HISTORIC AND DESIGN REVIEW COMMISSION

HDRC CASE NO: 2015-463
ADDRESS: 112 E PECAN ST
LEGAL DESCRIPTION: NCB: 139 LOT: 15 NATIONAL BANK SUB UNIT-2
ZONING: D RIO-3
CITY COUNCIL DIST.: 1
APPLICANT: Michael Lanford/Alamo Architects
OWNER: Mona Ghawi/Weston Properties, LC
TYPE OF WORK: Signage and Exterior Modification
REQUEST:

HDRC Case# 2015-463

WESTON EXTERIOR SIGNAGE
DOWNTOWN, SAN ANTONIO, TEXAS
NOVEMBER 13, 2015

ELEVATIONS - PROPOSED (N.T.S.)

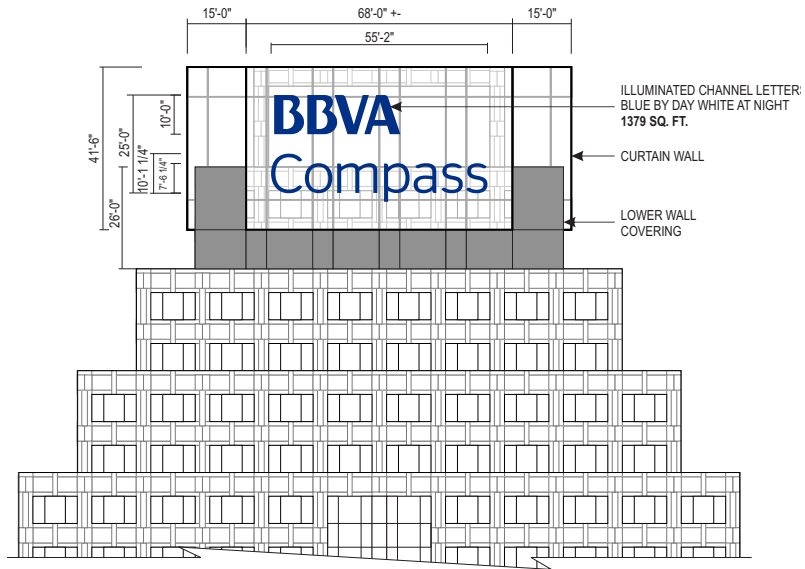
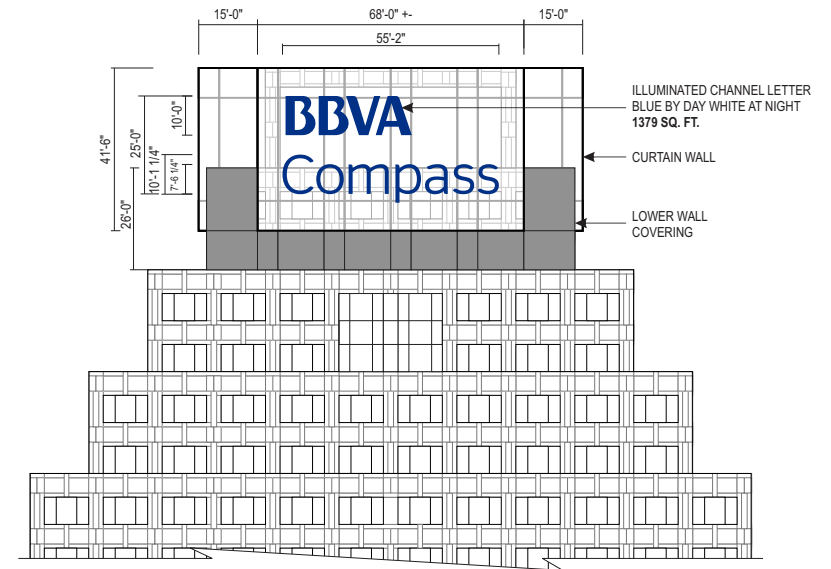
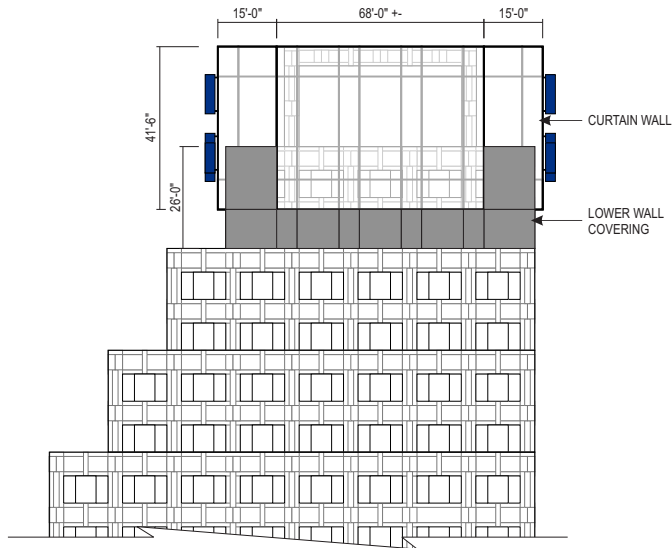
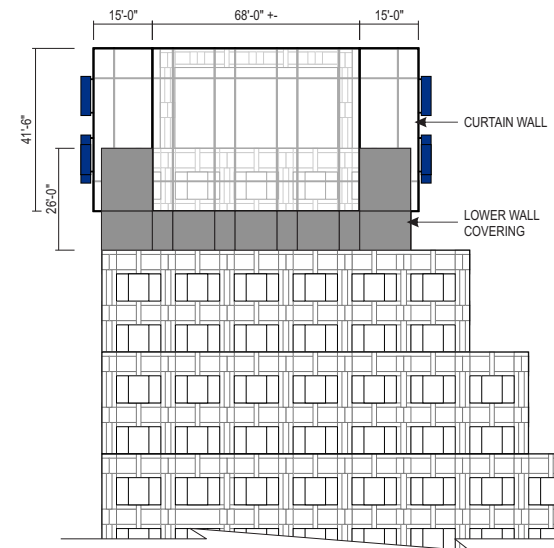
- e. The applicant has proposed to install (2) signs on the top of the north and south elevations, each approximately 55' in length and 25' in width upon a "lantern" type feature comprised by a curtain wall system made of a steel structure and glass panels with diffusers constructed atop the existing capital of the building. The proposed signage will be lit by LED lights. In addition to facilitation the proposed lighting system, the curtain wall system will obstruct viewing of the existing, rooftop communication equipment. UDC Section 35-681(c)(3) states that no signs shall be displayed from the parapet or roof of any building unless designated by the historic preservation officer as a contributing structure. Staff finds that the proposed rooftop installation of signage is appropriate given that this structure is a contemporary office tower.

- f. The applicant has proposed to modify the existing capital of the building to include a "lantern" that is to include a curtain wall system comprised of a steel structure and glass panels with diffusers. The proposed signage will be lit by LED lights. In addition to facilitating the proposed lighting system, the curtain wall system will obstruct viewing of the exiting, rooftop communication equipment. According to the UDC Section 35-681(c)(2), the maximum allowable size for any sign on the riverside of property abutting the publicly owned Riverwalk and visible from the Riverwalk shall by eight (8) square feet. The UDC Section 35-681(c)(3) states that no signs shall be displayed from the parapet or roof of any building unless designated by the historic preservation officer as a contributing structure.

- g. Staff finds that the proposed signage will be both viewable from the public right of way at the Riverwalk adjacent to the property at 112 E Pecan as well as from the public right of way on the Riverwalk immediately north of the E Houston Street bridge. The proposal to mount this signage at the rooftop level is not consistent with the UDC Section 35-681(c)(3).

COMMENTS/CONCERNS: MG: WILL BE DIFFICULT TO SEE THE ACTUAL
SIGNAGE FROM THE RIVERWALL, HOWEVER, LIGHTING GLOW WILL
BE VIEWABLE. QUESTIONS REGARDING MATERIALS- GLASS IS BEST,
ML: POTENTIALLY VIEWABLE FROM TURN IN RIVER AT AUGUSTA,
ARCHITECTURE IS CALLING FOR A "SLOTTED" LAP- NOT AN ABRUPT
TRANSITION AS PROPOSED, BUT AN INTEGRATED ONE. MG: EXPLORE
ADDITIONAL LAPS. DOES LAP NEED TO EXTRUDE? POTENTIALLY
DECEASED. LAP NEEDS TO BE PROPORTIONATE - ADDITIONAL HEIGHT MAY
BE APPROPRIATE.

STUDY Proportions on SLENDER ELEVATION
+ Engagement of 2 FLOORS BELOW crown
[Signature] Committee Chair Signature (or representative) 11/18/15 Date

Staff recommends conceptual approval of item #3 based on findings a through c and e, with the stipulation that the size of the "lantern" feature is scaled down to reduce total area to be illuminated.
